10/089,041

Please find below and/or attached an Office communication concerning this application or proceeding.

Office Action Summary	Application No. 10/089,041	Applicant(s) GRIMM ET AL.	
	Examiner Jerry Redman	Art Unit 3634

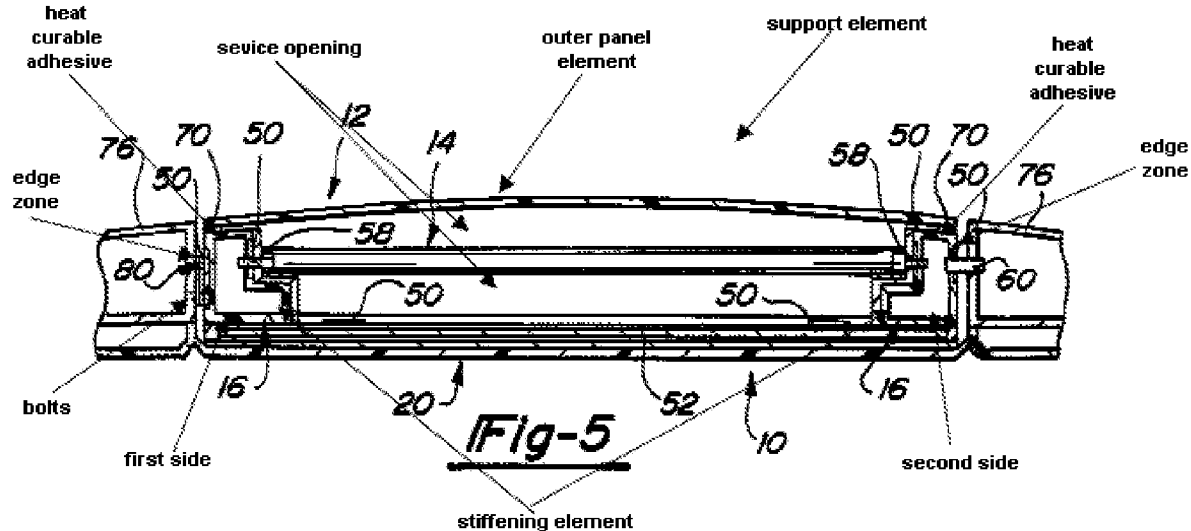
Claims 13-18, 20-30 and 34-35, 39-40 are rejected under 35 U.S.C. 102(b) as being anticipated by Ritchie (5,857,732). Ritchie (5,857,732) discloses a vehicle door module comprising a support element (see figure below), an outer panel element (12) to close the service opening along an edge zone, an elongated metal stiffening element (50), a spacing element (70) in the form of a heat curable adhesive (column 4, lines 34-67) which allows adjustability between the parts (i.e., the outer panel element and the elongated stiffening element) in two dimensions, which are to be fastened, and bolts (80) detachably joined to the stiffening element (50) and support element, an interior panel element (20), and a hinge (80).

The applicant's arguments have been considered but are not deemed persuasive. The applicant argues that the art of record, specifically Ritchie, does not disclose the spacing element contacting the stiffening element, the support element, and the outer panel element. As shown and discussed in detail above, the spacing element clearly contacts the outer panel element and the stiffening element. Furthermore, the applicant recites "the support element" which is read on Ritchie as being any and/or all parts of the "shell" of the door which forms the service opening in which almost all automobile doors have and therefore the spacing element would clearly be in contact with another other portion of the door that's not defined by the stiffening element and the outer panel element.
